December 1, 2022
File No. 16.0062961.02

Re: Wolverine World Wide, Inc. Consent Decree Court Case No. 1:18-cv-00039
Tannery Interceptor System Response Activity Plan Addendum

TANNERY INTERCEPTOR SYSTEM RESPONSE ACTIVITY PLAN ADDENDUM

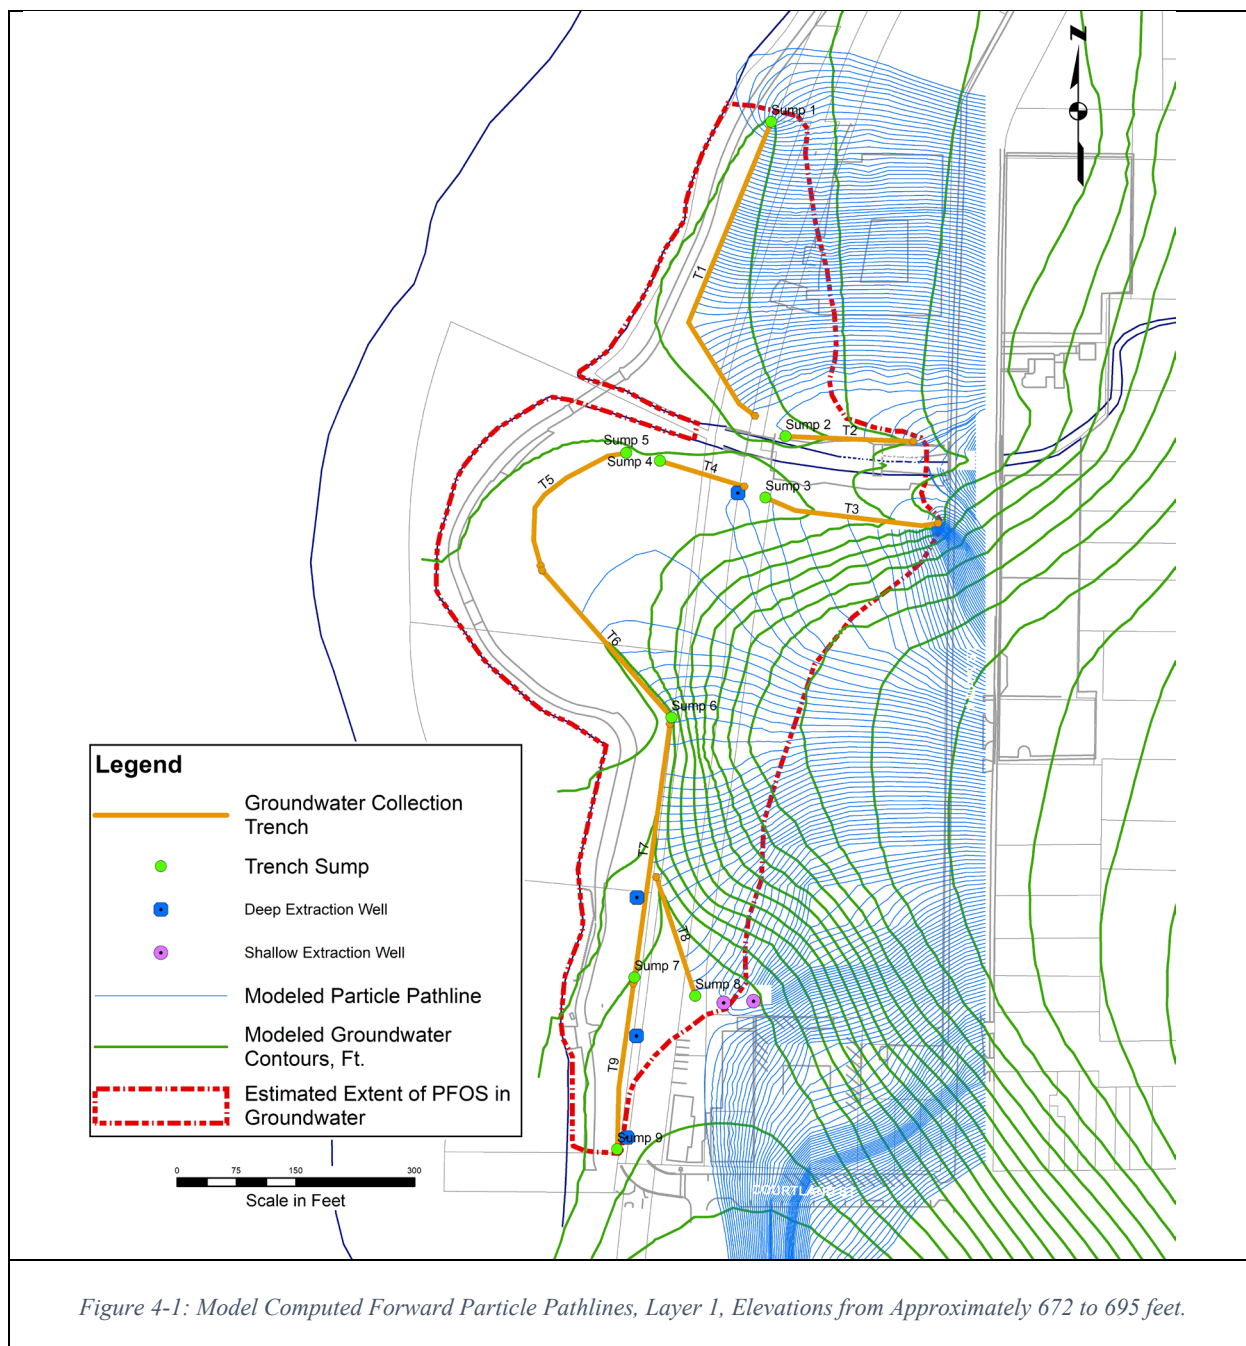
Figure 4-1 depicts the modeled effects of the interceptor system showing drawdowns from the trenches and extraction wells and an inward hydraulic gradient that intercepts groundwater flow to Rum Creek and Rogue River in Model Layer 1.

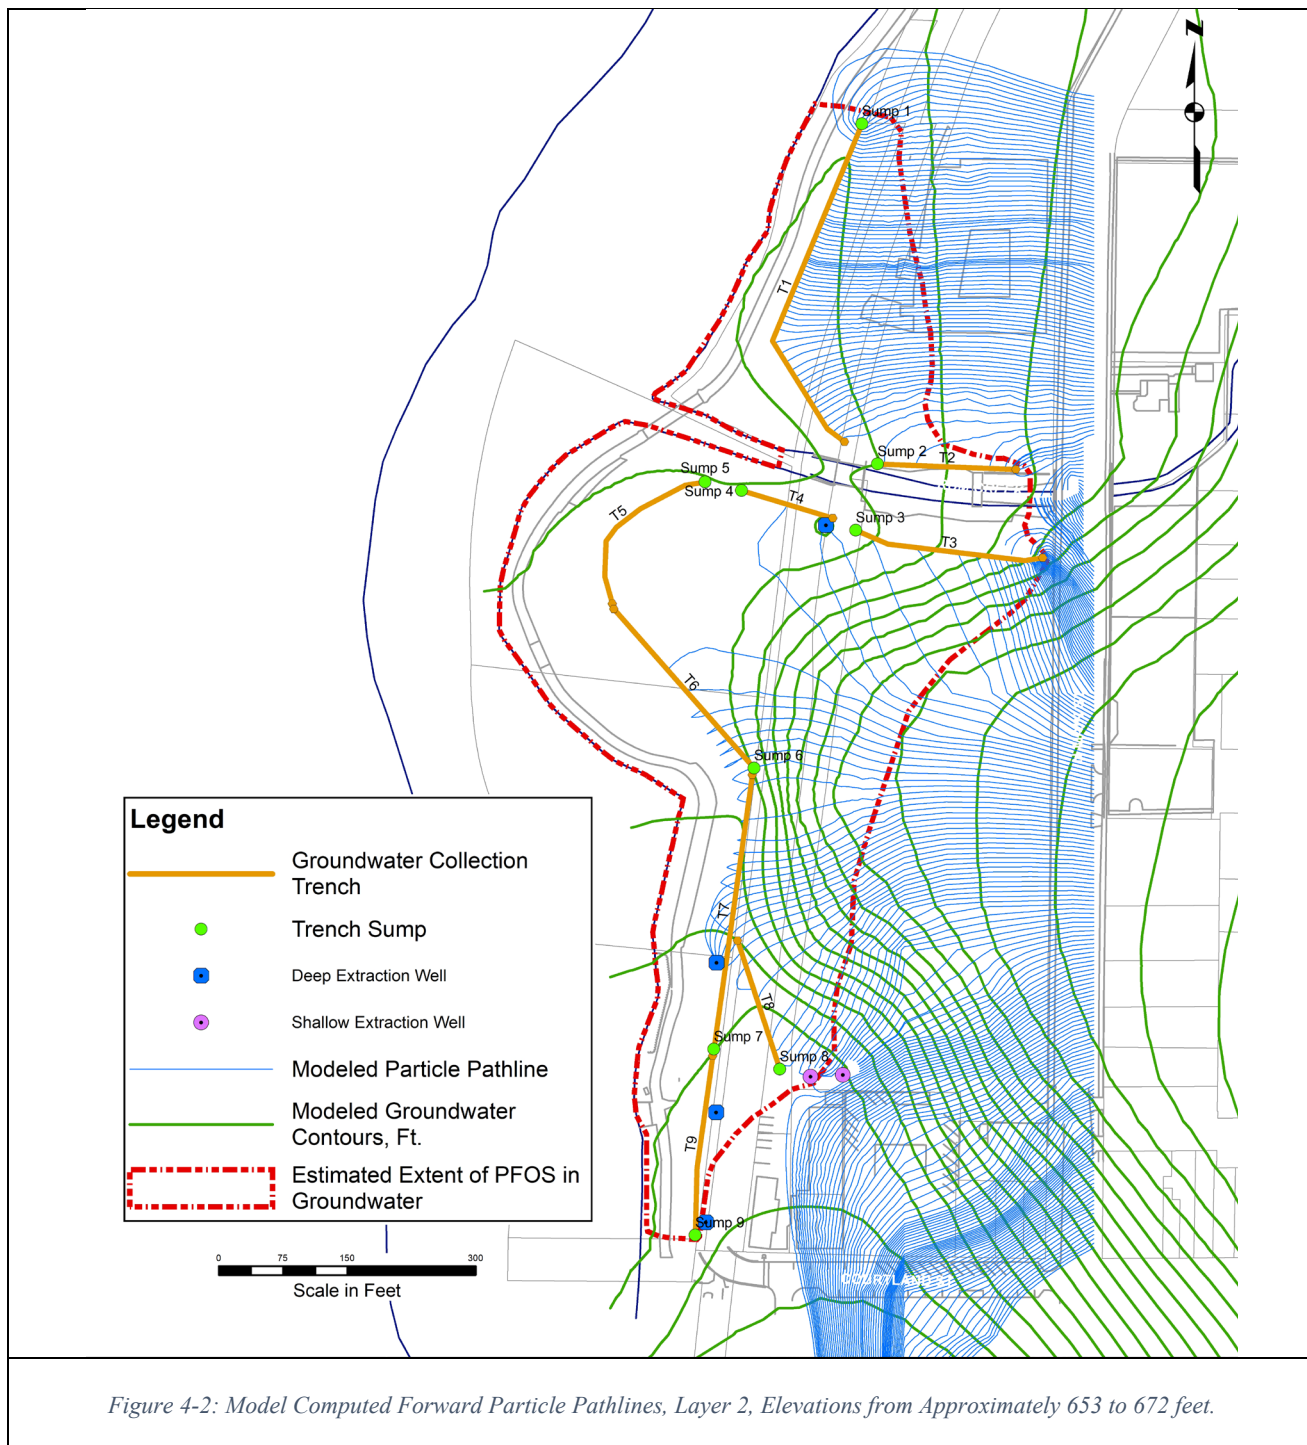
As shown in **Figure 4-2**, the model shows the interceptor system will produce inward hydraulic gradients which intercept groundwater flow to Rum Creek and Rogue River in Model Layer 2.

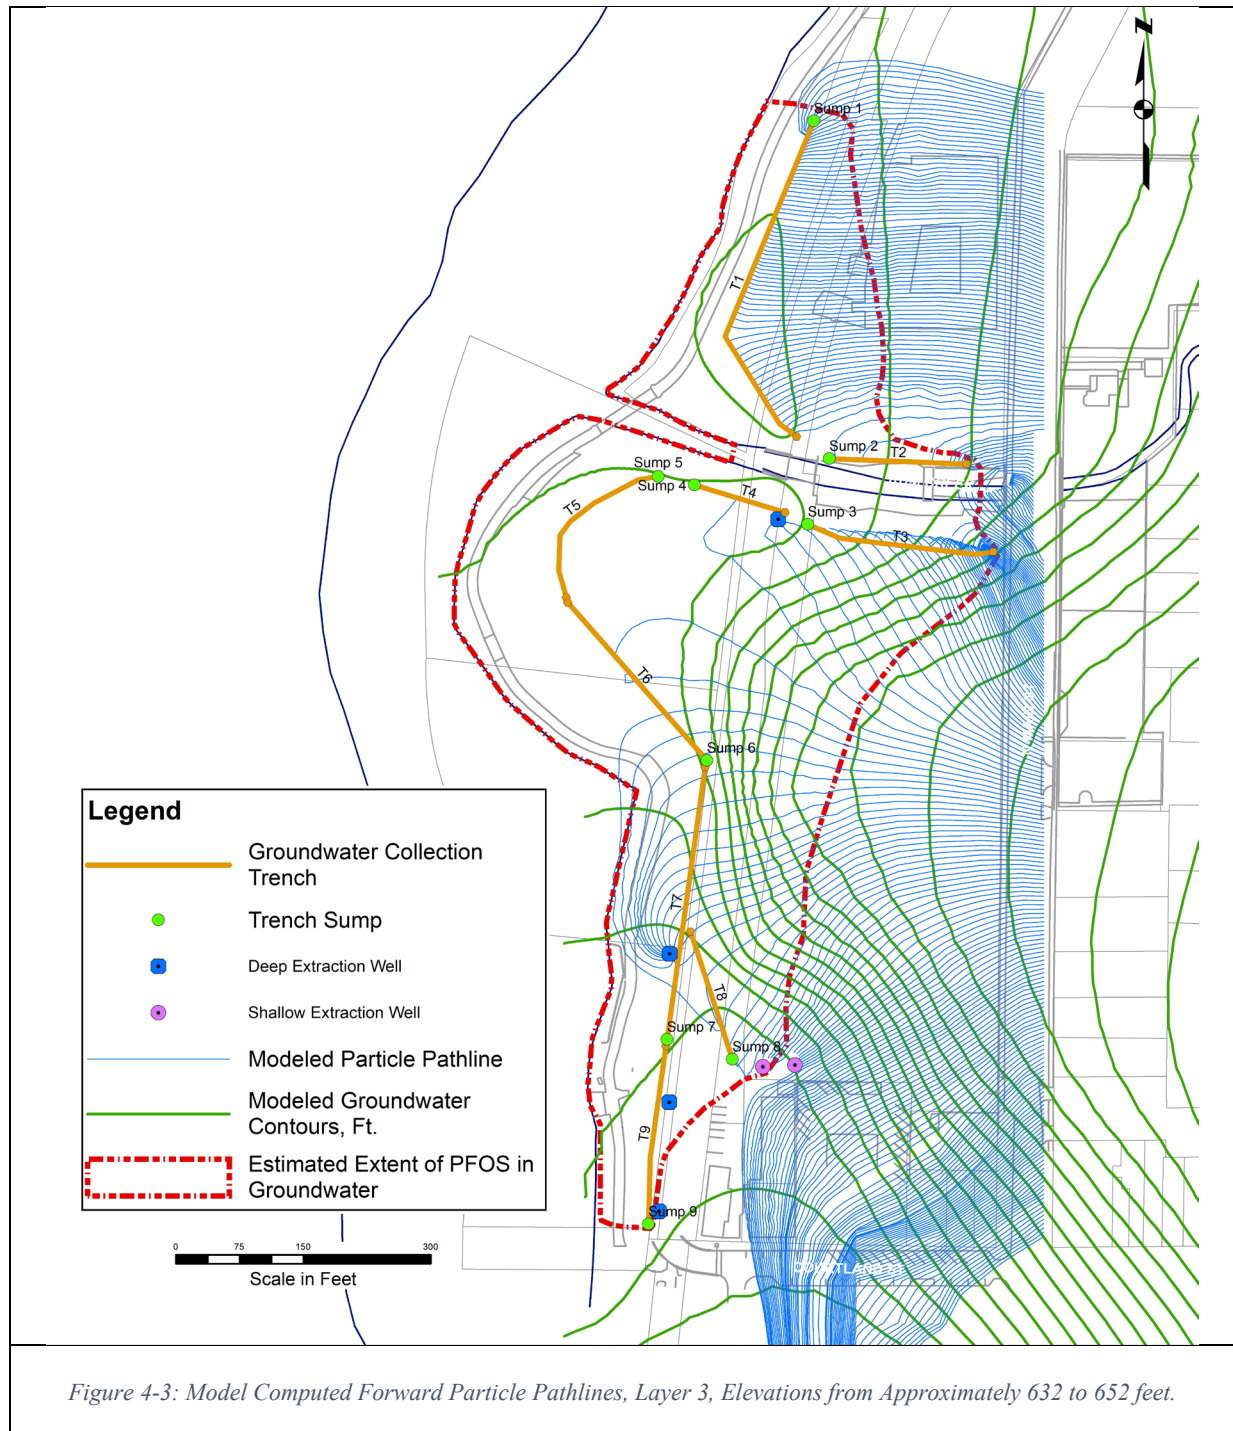
As shown in **Figure 4-3**, the model shows the interceptor system creates inward hydraulic gradients to intercept groundwater flow to Rum Creek and Rogue River in Model Layer 3.

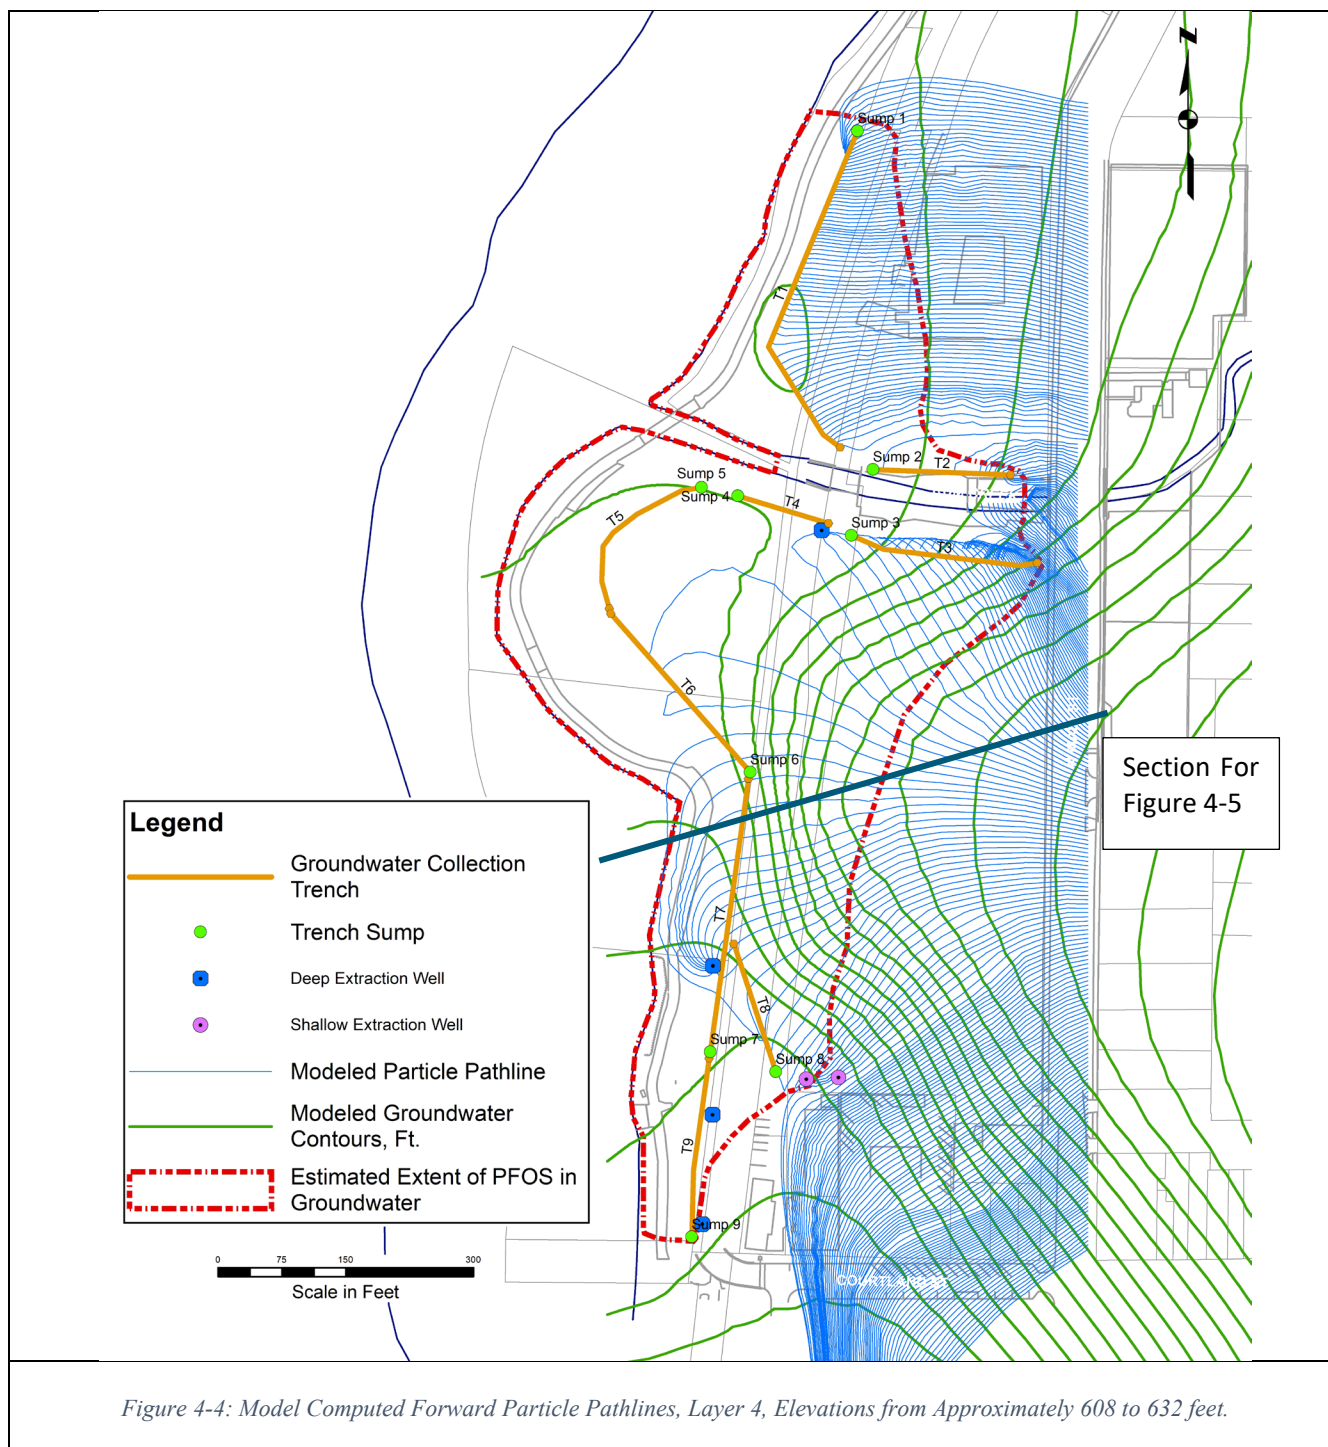
Figure 4-4 shows the interceptor system is also able to create inward hydraulic gradients and intercept groundwater flow to Rum Creek and Rogue River in Model Layer 4.

Figure 4-5: Model Computed Pathlines, West-East Cross-Section Profile

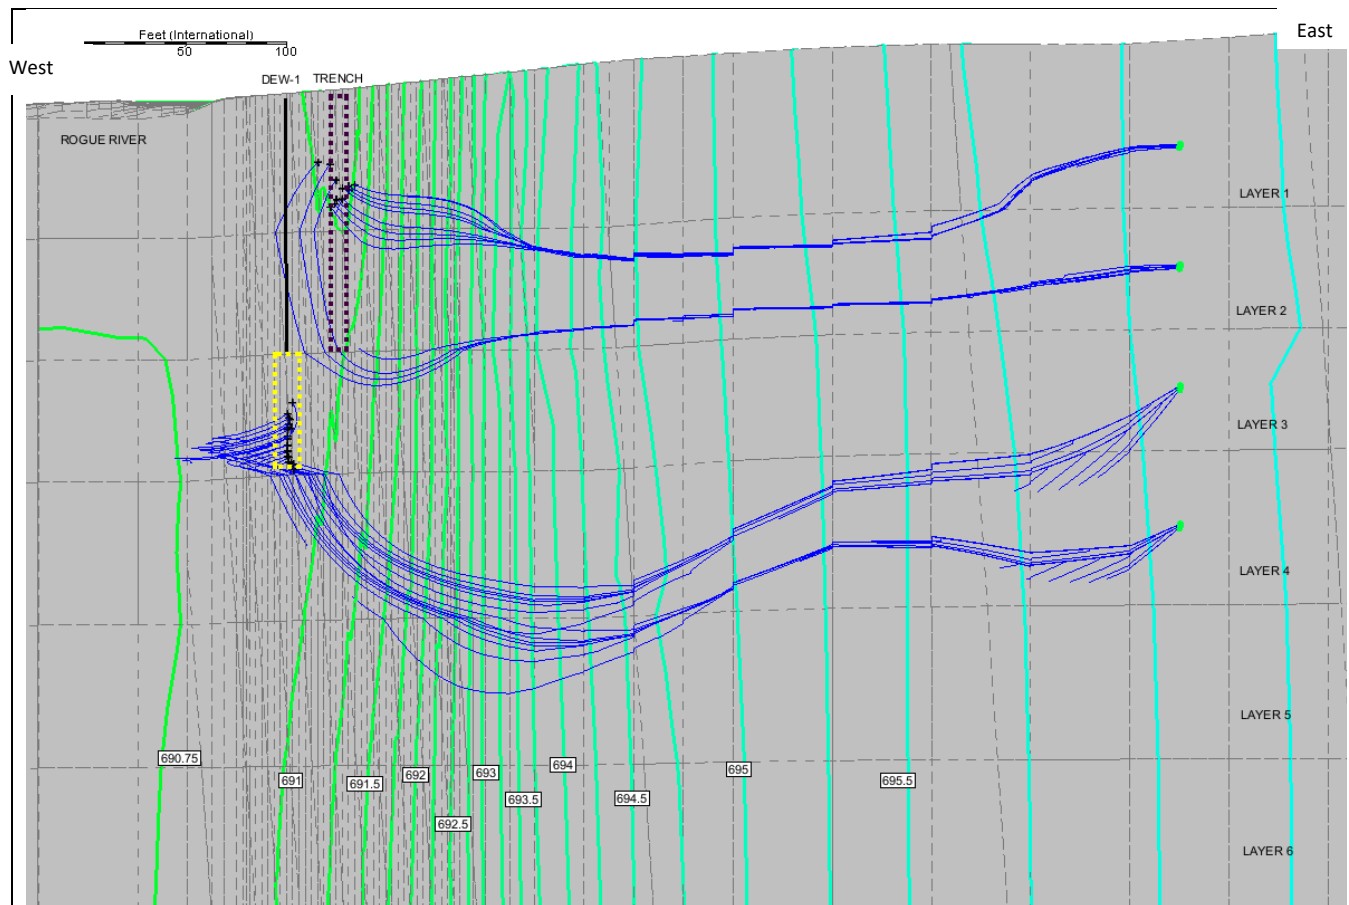
Figure 4-5 shows modeled path lines in vertical profile, the vertical capture zone reaches to Layer 4 (bottom elevation 608 feet).
